Access Compliance Report

Public Rights-of-Way

(Curb Ramps)

Intersection ID: N/A	Main Street: BEREWICK_TOWN_CENTRE	Cross Street: N/A	Location: NW
ADA ID: 59F058CA1BDA	Ramp Type: Perp	Initial Pass/Fail: Pass	Overall Compliance: No
Severity Score: 0			
Codes/Mitigation Info/Possible Solution		Field Measurements/Component Compliance

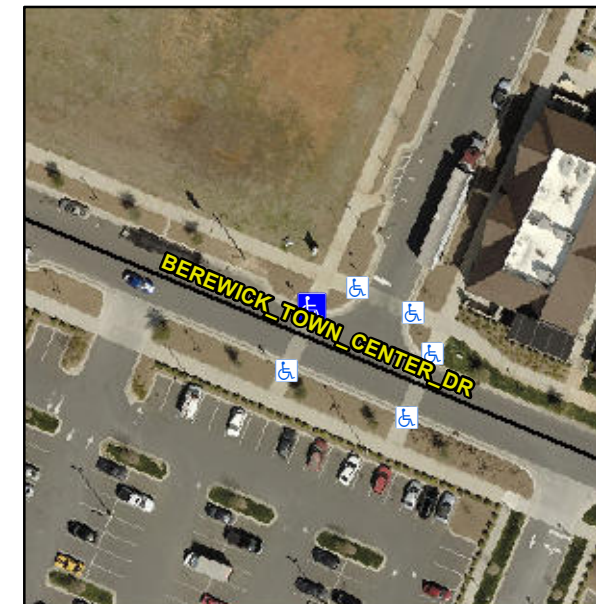
Possible Solutions:

Remove & Replace Entire Ramp.

Not Found, R305.2
